**Subject: MHI's Responses to US-APWR DCD RAI No.641-5045 Revision 1 (SRP 19)**

**Responses to Request for Additional Information No.641-5045  
Revision 1**

**US-APWR Design Certification**

**RAI NO.:** NO. 641-5045 REVISION 1  
**SRP SECTION:** 19 – Probabilistic Risk Assessment and Severe Accident Evaluation  
**APPLICATION SECTION:** 19.1.5.2  
**DATE OF RAI ISSUE:** 09/27/2010

Figure 1 MCR Event Tree

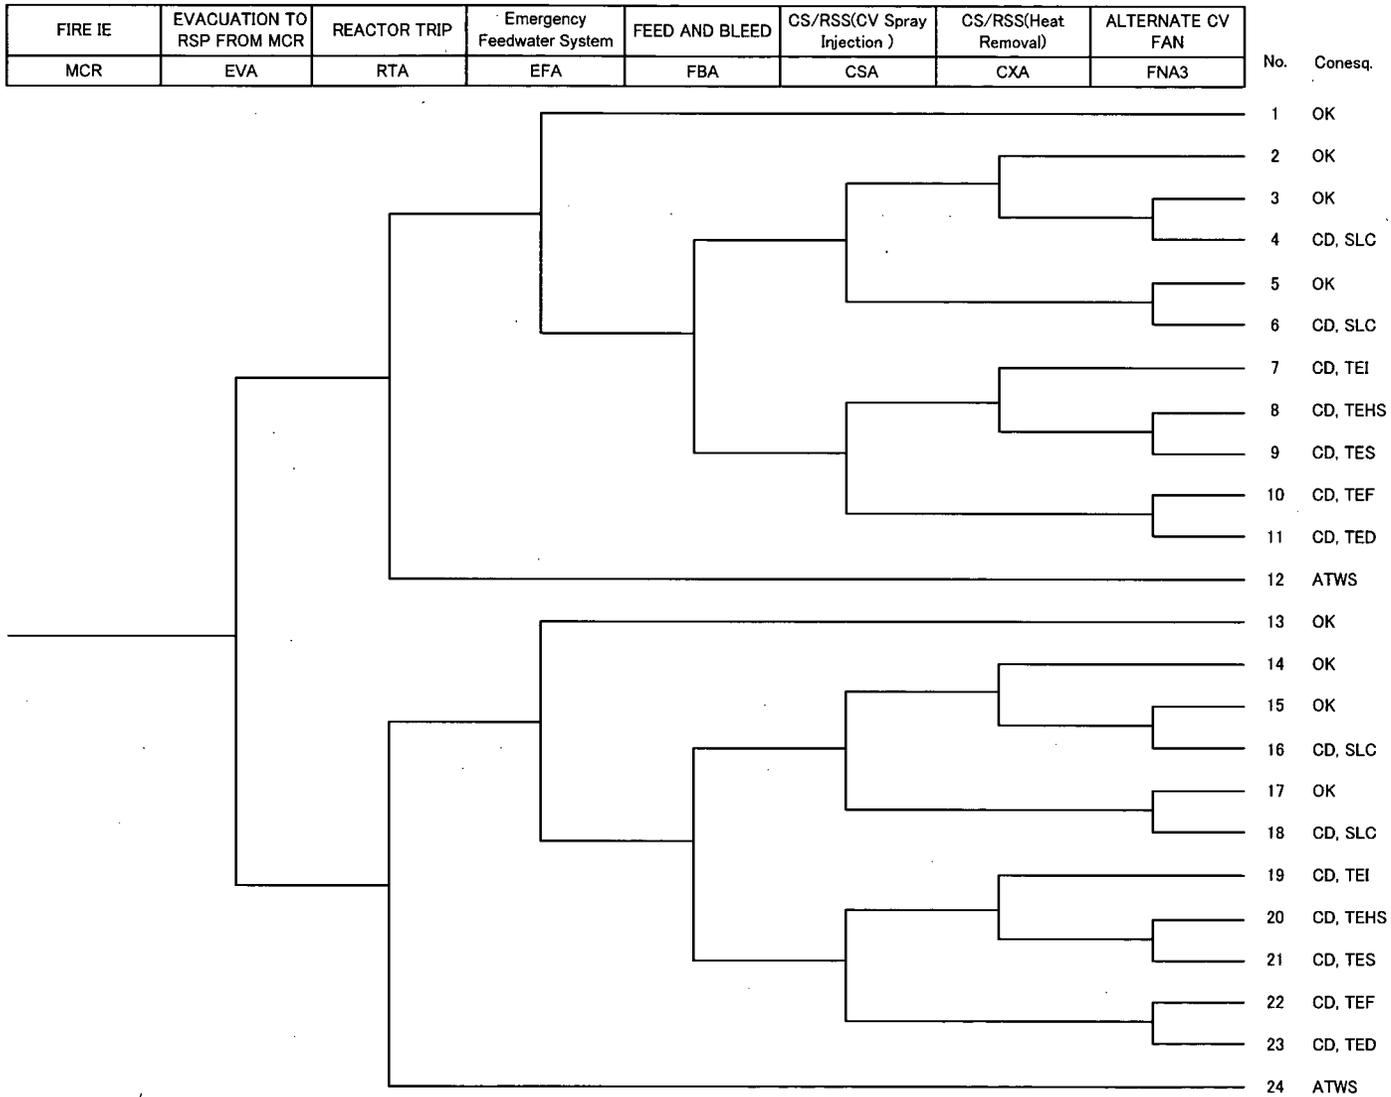
For the fire event trees currently reported in Chapter 23 and Appendix 23H of the USAPWR PRA, the staff review notes that there is no description of the event tree top events and that the success criteria for each top event are not stated in the fire PRA. Please provide this information and revise the fire PRA accordingly (e.g., a table could be added that includes a description and the success criteria for each top event identifier).

Moreover, because it is assumed that any fire in the MCR will not damage the mitigation function, the MCR ET has been developed based on the TRANS ET of the internal events PRA, but EVA has been added as the top event of the MCR event tree. The MCR ET is shown in Figure 1.

The success criteria of the MCR ET are equivalent to those for the TRANS ET.
